## River Deel (Crossmolina) Drainage Scheme

NIS Addendum

<b>Client</b>	<b>Office of Public Works</b>
<b>Project Title</b>	<b>River Deel (Crossmolina) Flood Relief Scheme – Environmental Services</b>
<b>Report Title</b>	<b>NIS Addendum</b>

SECTION C02-12 (NEW)

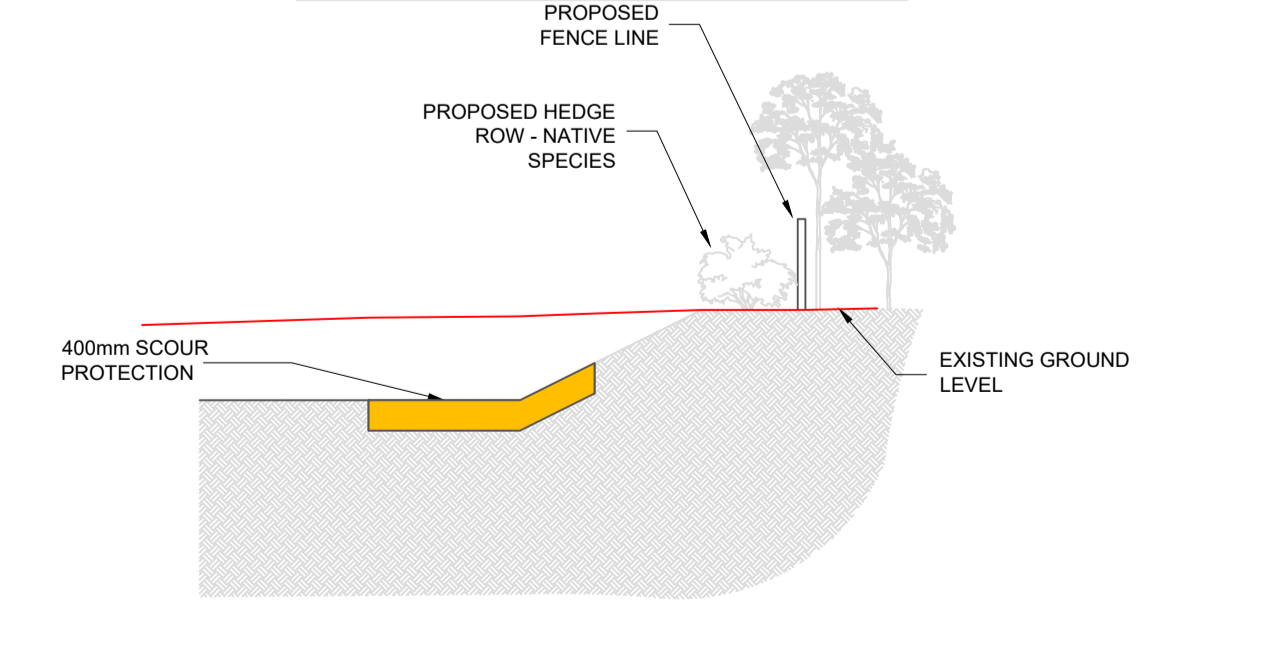
- Rock armour/ stone gabions will be placed in order to provide scour protection to the river banks upstream and downstream of the intake location as detailed in Appendix II (Drawings L\_01 and S\_01) and (Drawing SP\_01). This bank protection extends 90m upstream of the proposed intake structure and 80m downstream of the structure and will be undertaken by excavating on the bank and replacing the excavated material with rock armour or stone gabions.
